No: SB077 Rev: 0 Date: March 12, 2013

500/650-ECI/S-900/1350 and 500/650-HCI/S-750 Torque Bushing Clevises

Figure 1: Overall failure of the extend frame clevises

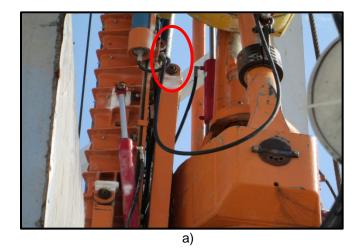
An incident has occurred where the extend frame clevises on a torque bushing used on a 500-ECI-1350 Top Drive failed at the welds during a drilling ahead operation (see Figure 1). A preliminary investigation points to a lack of fusion between the weld material and the clevises as the significant contributing factor in this failure. Figure 2a shows the failed weld; Figure 2b shows a portion of the weld with evidence of lack of fusion. TESCO has identified a single vendor that had provided faulty torque bushing products since 2010. As a field retrofit procedure, TESCO is recommending to grind out the existing welds and replace them with a revised weld. A revised drawing of the front plate (TESCO part number 14728 Rev 9) has been issued to assist in the rework of all existing units.

Notwithstanding the fact that this incident did not result in significant damage, if a similar failure were to occur while rotating, severe damage (up to and including injury or death) could result from the top drive rotating unrestrained in the mast. TESCO advises that the top drive should not be used to provide rotation (drilling, torqueing of connections, etc.) until such time as a repair is undertaken.

- 1. The welds attaching the clevises to the torque bushing front plate (part number 14728) are to be fully ground out and replaced with 3/4" fillet welds under an approved weld procedure for A514 grade material (Quenched and Tempered 100 ksi yield plate) as specified in revision 9 of (part number 14728).
- Ensure that the rework is performed by a qualified welder using an approved weld procedure specification suitable for A514.

Until such time these actions can be taken, a safety sling with a capacity of 5 tons and sufficient slack to allow for full extend should be attached between the torque bushing and the top drive yoke to prevent a potential dropped object incident.
